CITY PLANNING COMMISSION

APPLICATION: Application to reduce the required 20 ft. driveway length to 6 ft.

LOCATION: 808 - 28th Street

P88-274

EXHIBIT A

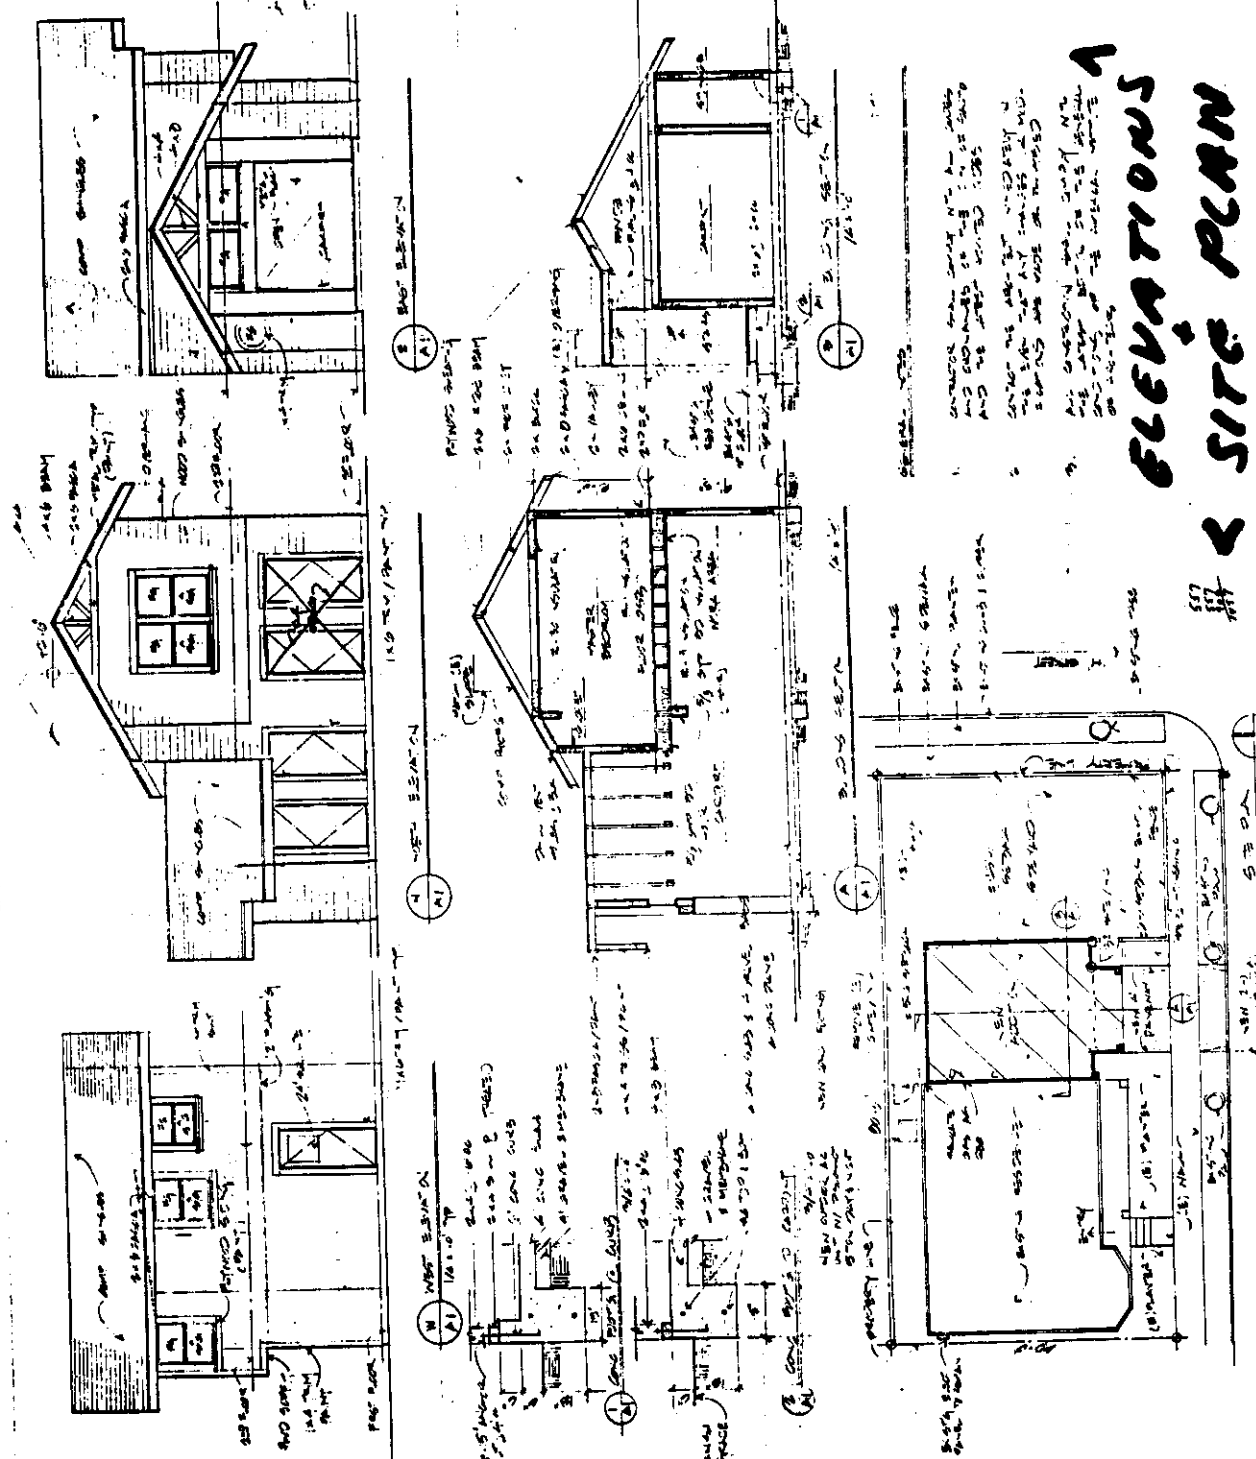
As indicated on the site plant (Exhibit A) the applicant is proposing an addition to the home along the north elevation. The addition is approximately 24 ft. by 27 ft. with a carport on the lower level and a master bedroom on the upper level. The proposed elevations are shown in Exhibit A and the floor plans in Exhibit B. The site plan indicates that the driveway will be six feet long with access off of 28th Street. The applicant has indicated the following reasons for wanting the driveway in this location:

EXHIBIT C

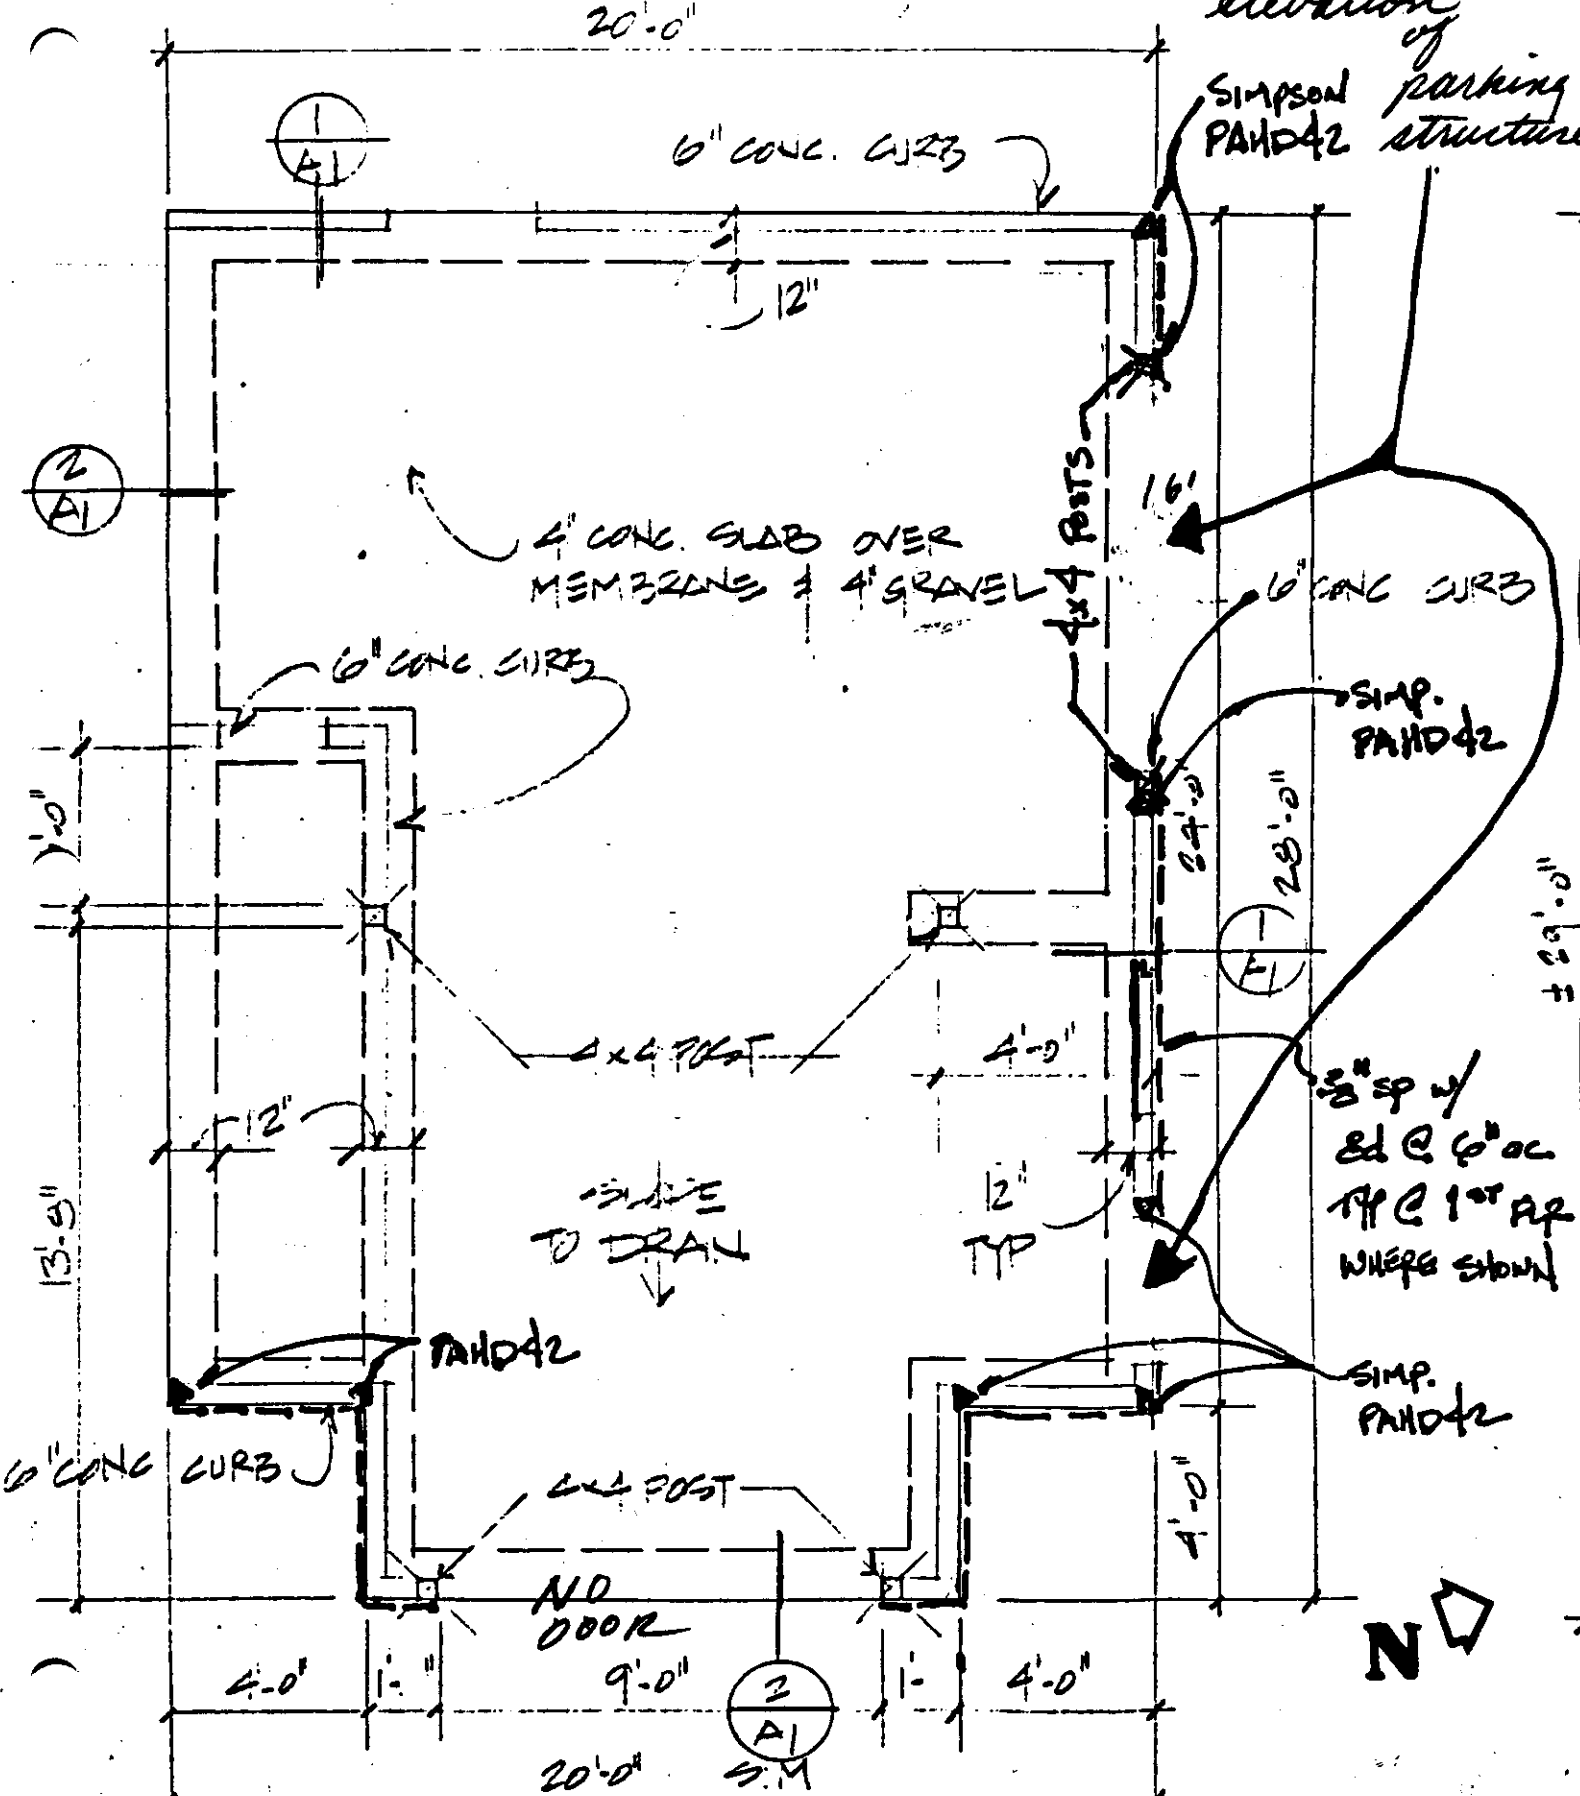
Staff met with the applicant to discuss a design that would deter a door from being added on the east elevation of the proposed carport in the future. Although the applicant has indicated no door will be located at the entrance, staff is concerned that a future tenant could add the door later. The applicant was willing to add two openings (16 ft. and 7 ft.) along the north elevation of the parking structure for the purpose of emphasizing the open carport design (see Exhibit C). It is staff's finding that a future tenant is unlikely to add a door due to the fact that the door would not actually enclose the garage.

1. The parking structure shall be designed with the 16 ft. wide and seven ft. wide openings as shown in Exhibit C along the north elevation.

EXHIBIT D

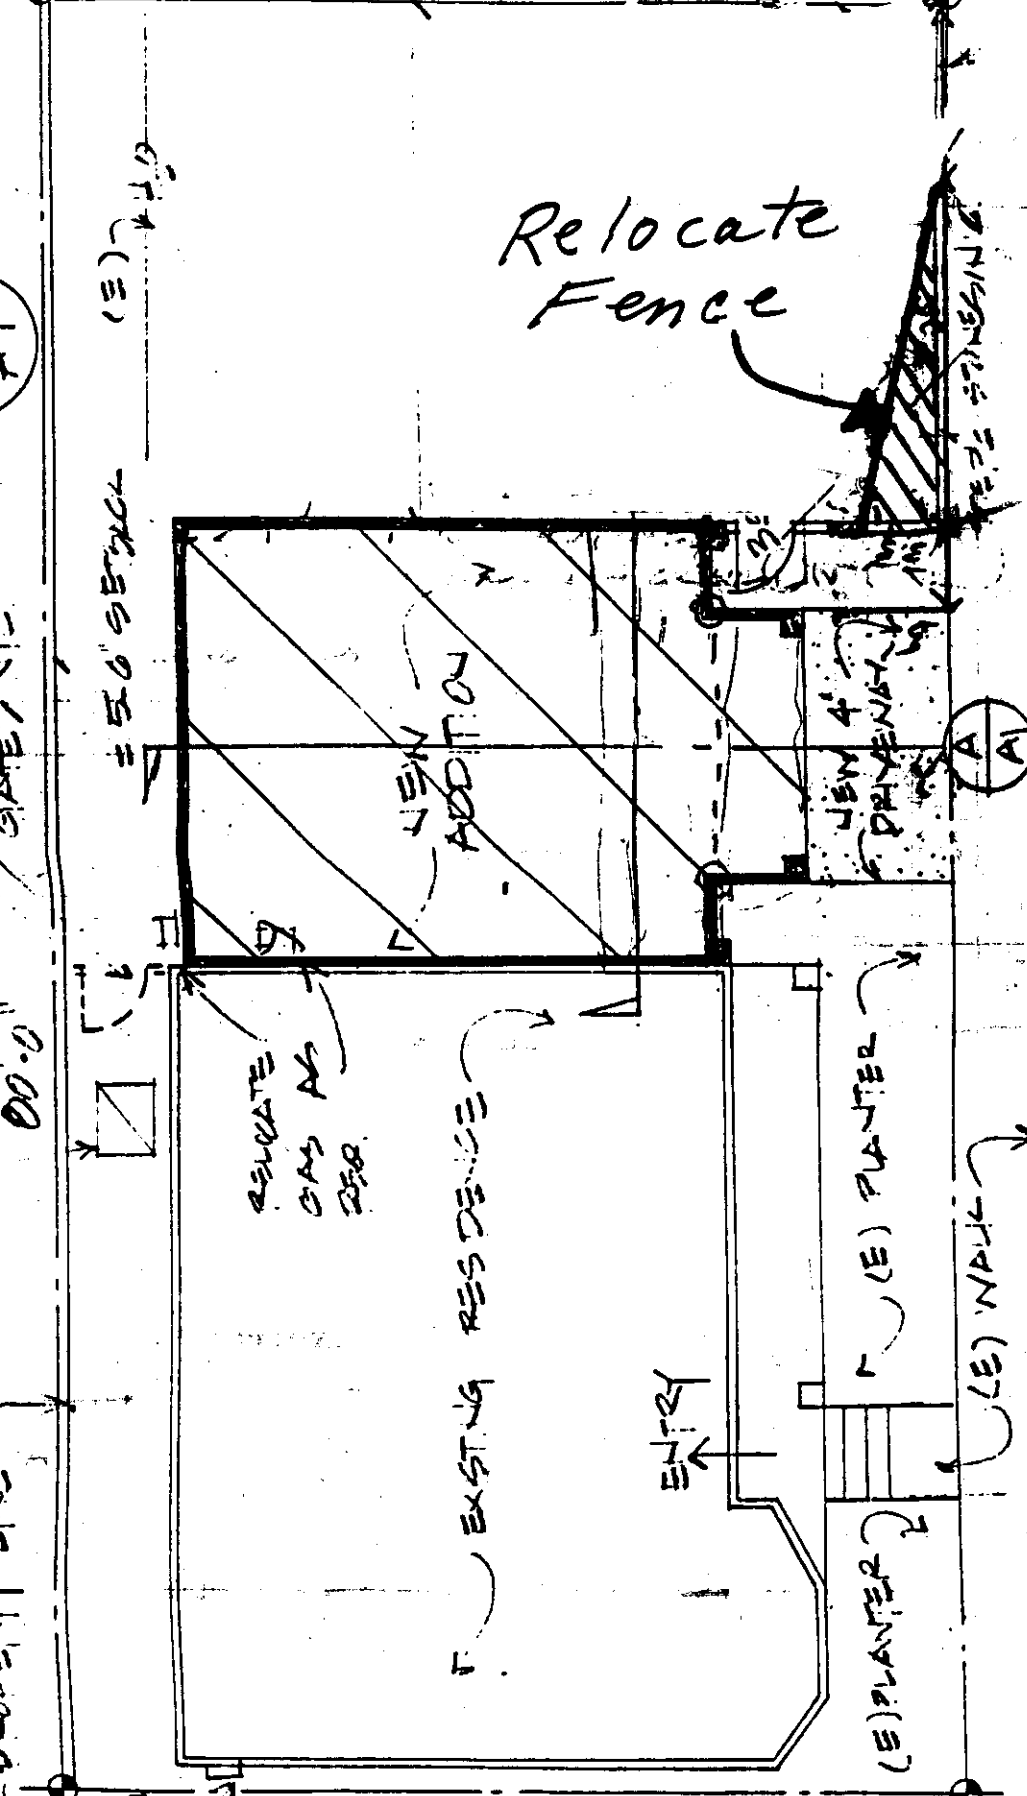
The applicant has indicated that the corner of the existing six foot high wood fence nearest the driveway (see Exhibit D) will be redesigned to meet the clear zone requirements of the Zoning Ordinance. This will allow the driver adequate visibility when backing out of the driveway.

2. The entrance to the parking structure shall remain permanently open.
3. The applicant shall meet the clear zone requirement of the Zoning Ordinance pertaining to the corner of the fence nearest the driveway. The design shall be reviewed and approved by the Design Review Board.
4. The project shall be reviewed and approved by the Design Review Board prior to the issuance of building permits.
